City of Alexandria, Virginia

MEMORANDUM

SUBJECT: 4th CONCEPT REVIEW OF 2 DUKE STREET
(FORMERLY ROBINSON TERMINAL SOUTH)
BAR CASE # 2014-0113

1-View from promenade at Point Lumley Park
Previous Submission

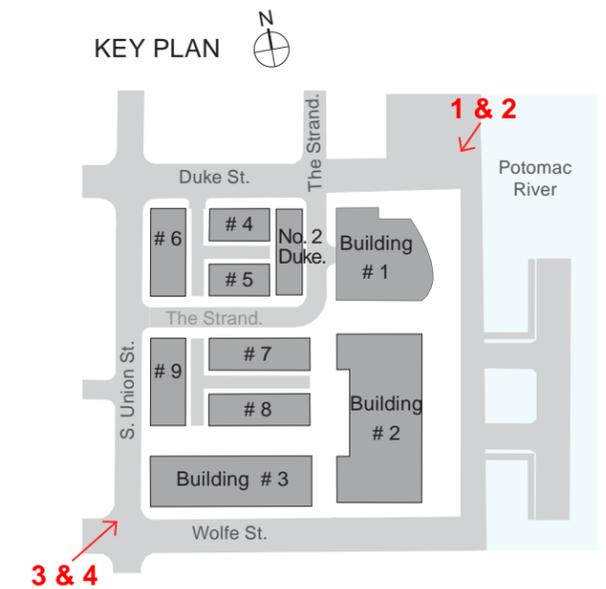
The initial designs for Buildings 1 and 2 on the waterfront, presented at the second work session in July, were very contemporary, organic and almost disordered structures that drew their inspiration from contemporary global architecture. The Board reacted strongly against these

designs, finding them to be disconnected from Alexandria building traditions, forms and materials and lacking a sense of place. At the last work session (#3), the architect presented a contemporary interpretation of the Alexandria waterfront shown in 19th century photographs: a building bay spacing related to size of the historic warehouses, with slightly curving bay windows referencing the curve of sails and “mast” inspired vertical posts of the ships anchored at the wharfs in front of those historic warehouses. That proposal introduced a rhythmic, repetitive and articulated design that recalled the seafaring past of the Alexandria waterfront and was generally supported by the Board, though some expressed concern that five almost identical bays was too much of a good thing.

important points regarding the waterfront buildings. First, that Building #1, the northeast corner of the site, should be a signature building or the “gem” of the project site. The northeast corner of this building should visually attract attention and draw people into the site. The second comment, related to the first, was that Building #1 should be differentiated from Building #2 so as to prevent the monolithic appearance of a single “project” on the waterfront side of this block. Staff does not believe that the current design of Building #1 responds to the BAR’s two primary comments because it is not the *pièce de résistance* the Board was looking for. It is recommended that the applicant expand the curving glass element containing the ground floor restaurant from one story to two-and-one-half or even three stories in height, reinforcing a basic 30’ street wall on this facade. Additionally, the curving feature element should wrap farther around the north elevation so that it is clearly visible from the north on the promenade. Innovative lighting for the proposed restaurant would further enhance this feature. Moreover, a primary entrance adjacent to this prominent corner should be highlighted to further emphasize the welcoming public character of the adjacent parks. Staff thinks that creating such a celebrated corner piece will result in sufficient differentiation between the two waterfront buildings to effectively meet the BAR’s comment regarding variation.

As the first floor of both waterfront buildings will be almost entirely commercial or non-residential amenity space, staff recommends that they be refined to visually express this ground level distinction. As currently shown, the doors and windows at the first story are the same as the residential doors and windows above. The applicant has included tables, umbrellas and signs to convey a pedestrian “friendliness” in this area but the architecture must be enhanced to further express the public and non-residential nature of the first floor so that the public feels welcome to use this open space on the waterfront.

- Emphasize the northeast corner of Building #1 to make it a feature element
- Reduce the height of the waterfront "masts" to comply with zoning
- Distinguish the public nature of the first floor level of Building #1 & #2 on waterfront and park elevations from the upper level residential uses and create a first floor architectural character that is inviting and engaging at the pedestrian level
- Provide a clear setback and transition above the 30 foot height on the waterfront façade of Building #1 & #2
- Restudy Building #3 to improve the transition at the southwest corner and to employ an architectural character that is compatible with the overall site and complementary to adjacent residential buildings through increased setbacks at the fourth and fifth stories that are meaningful

BLDG #3 - EAST ELEVATION

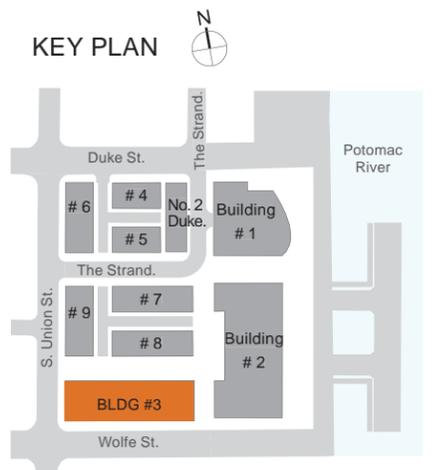
As the multifamily building at the southwest corner of the site, Building #3 mediates the transition from the glassier waterfront side of the block to the more traditional architectural character of the adjacent buildings on Wolfe Street and South Union Street through the presence of more masonry with punched windows and a repetitive series of bays. This building must also function as an appropriate transition to the large non-historic townhouses and electrical substation to the south and west, as well as the proposed new townhouses to the north. Therefore, staff recommends that the southwest corner of Building #3 be further stepped back so as to provide a more appropriate transition by removing the top level projecting balcony and stepping back the building plane. Figure 3 shows a massing study which illustrates how such upper level setbacks could be incorporated.

The design intent for Building #3 to mediate between the more traditional forms and materials of the townhouses on South Union Street and the more contemporary waterfront multifamily buildings is appreciated and provides architectural variety for the overall project. However, while significantly improved, staff continues to find that this third multifamily building is less successful than either the two multifamily buildings on the waterfront or the townhouses. While the projecting bays and upper floor setbacks on the south elevation define the 30 foot street wall, establish a clear townhouse width rhythm and provide pronounced shadow and articulation, the architectural character is less clear, particularly at the top floor level, and the residential character of the building is vague and lacks human scale detail.

Additionally, as the Wolfe Street façade is revised, the building must be viewed in its entirety, as there is no true rear elevation. The four elevations must coordinate and the north elevation should feature the same level of detail and interest as the street-facing elevations, which may incorporate balconies.
